URBAN DESIGN COMMITTEE MEETING MINUTES

8.2 UDC-18-001 144-176 John Street (Randwood Estate) - Hotel & Conference Centre - Zoning By-law Amendment

January 17, 2018
Urban Design Committee Report UDC-18-01

Subject: 144 & 176 John Street East (Randwood Estate) – hotel and conference centre – Zoning By-law Amendment

Figure 5: Cross-section of hotel building with trees

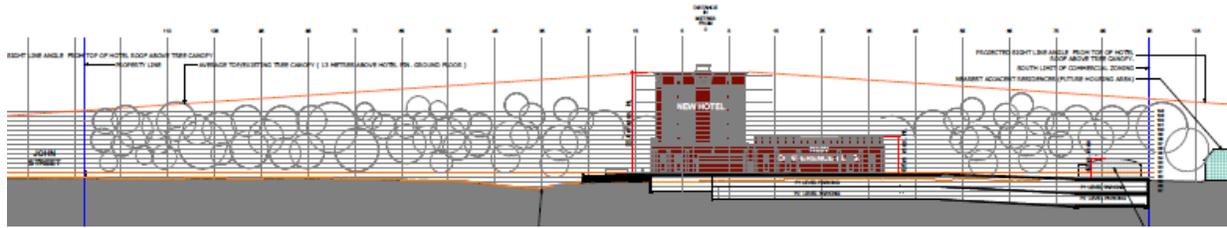
massing of the building at six storeys. This building would be the tallest in Old Town and would be comparable in height and massing to the hotels that are under construction in Glendale. Additionally, the hotel is proposed to be higher than the canopy of trees on the property, and can be viewed from the Commons. *Staff seek the Committee's advice if the height and massing are appropriate for the subject property and complementary to the surrounding neighbourhood.*

Figure 7: Landscape plan

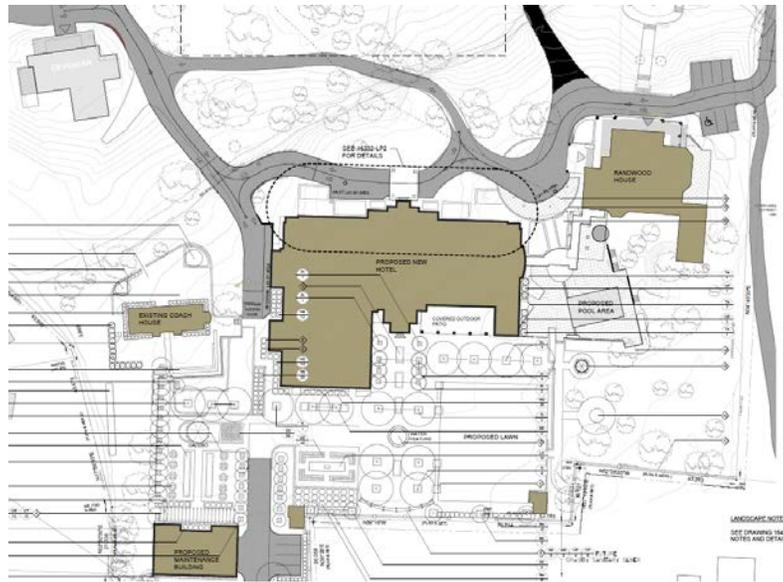
The landscape plan indicates that there will be vegetative screening provided along the western side of the terrace, presumably to screen the residential subdivision on Christopher Street. The plant list does not provide the specific species for 'CO' for this screening and thus, Staff seek clarity from the applicant. Staff do have concerns about the viability of the trees proposed on the terrace and if their growth can be sustained when planted on a raised terrace. In general, Staff are supportive of the landscaping on the terrace, with its variety of plantings that are ornamental and grown in rows of raised planting beds. Staff appreciate the idea of providing, at the rear of the hotel building with a modern landscape, a contrast from the earlier, more traditional design of the Dunnington-Grubb landscaping at the front of the property. *Staff seek the Committee's advice on this dual landscape.*
